Product / Process Change Notification (PCN)	
<input type="checkbox"/> Major Change <input checked="" type="checkbox"/> Minor Change	
PCN Number: PCN_UtAGDT_20240610 Affected Series: WE-AGDT Affected Order Codes: 75031XXXX PCN Date: 2024-03-08 (YYYY-MM-DD) Effective Date: 2024-06-10 (YYYY-MM-DD)	Change Category: <input type="checkbox"/> Equipment/Location <input checked="" type="checkbox"/> General Data <input type="checkbox"/> Material <input type="checkbox"/> Process <input type="checkbox"/> Product Design <input type="checkbox"/> Shipping/Packaging <input type="checkbox"/> Supplier <input type="checkbox"/> Software
Contact: Product Management Phone: +49 (0) 7942 - 945 5001 Fax: +49 (0) 7942 - 945 5179 E-Mail: pcn.eisos@we-online.com	Datasheet Change: <input checked="" type="checkbox"/> Yes <input type="checkbox"/> No Attachment: <input type="checkbox"/> Yes <input checked="" type="checkbox"/> No

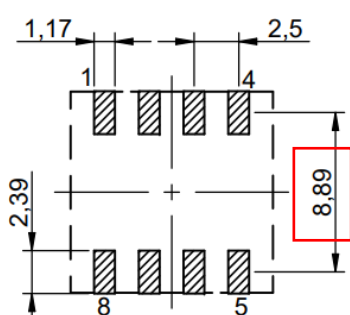
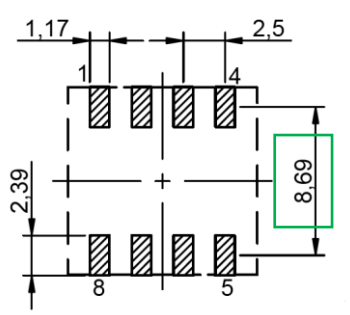
Description of Change: <p>As a datasheet information amendment, Würth Elektronik will update the center of pad to center of pad width dimension on the recommended land pattern from 8.89 mm to 8.69 mm.</p> <p>This is a datasheet correction only. There will be no change in form, fit, function, quality or reliability of the product.</p>	
Details of Change: <p>The change of the center of pad to center of pad width dimension on the recommended land pattern can be seen below.</p>	
Before Change 	After Change
